**Subject:** Re: Koeffler House, AKA Dubbel Dutch

I'm ready to release my mason, North Shore Brickwork and Windows from Rolling Meadows, IL, on the tuck pointing for the front porch area on the project at 817-819 N. Marshall St.

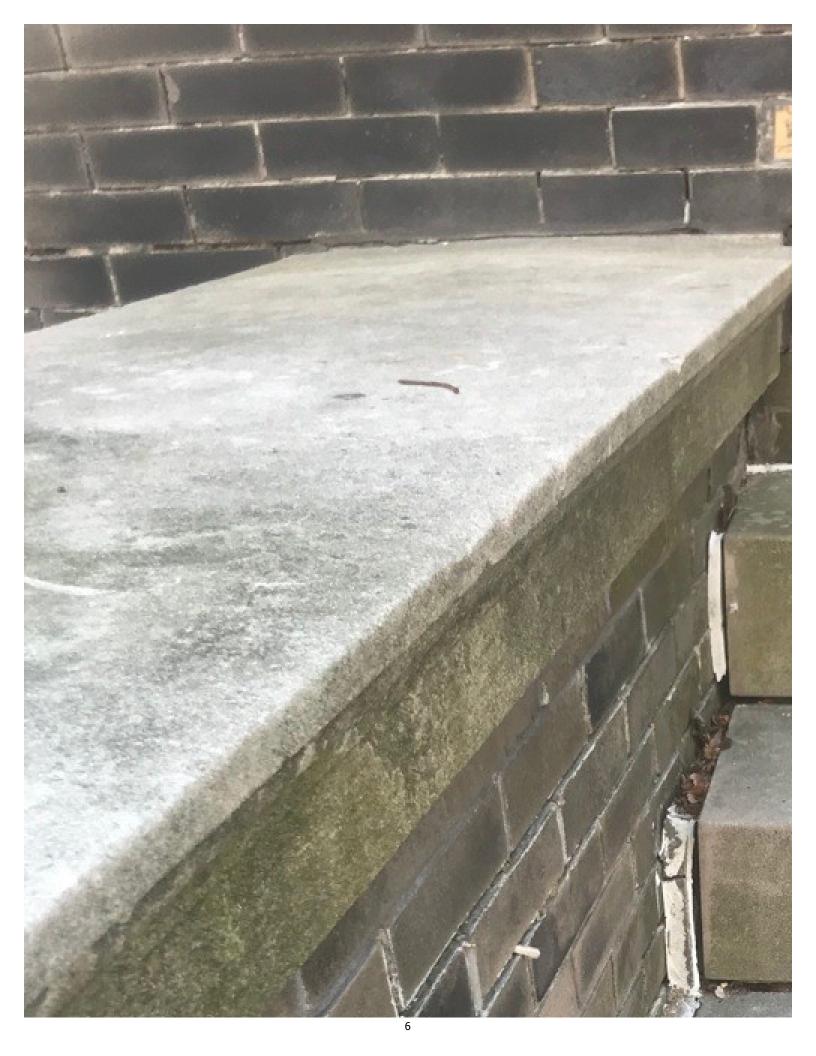
N from above flaring out from steps

S from above, flaring out from steps.

S from front, shows increasingly large gap between walls and steps.

N front, I hand displaced those bricks, then slid them back in. mortar samples.	Masons have the missing brick for a match if necessary, and
	7

N interior face

S interior face

S front / interior face, again, I hand displaced those bricks, could pull them out entirely. Mortar gone.

S front face

Please thoroughly photograph the wing walls and submit the photos to me before dismantling begins (3-5 photos each side). Otherwise, proceed as you have indicated.
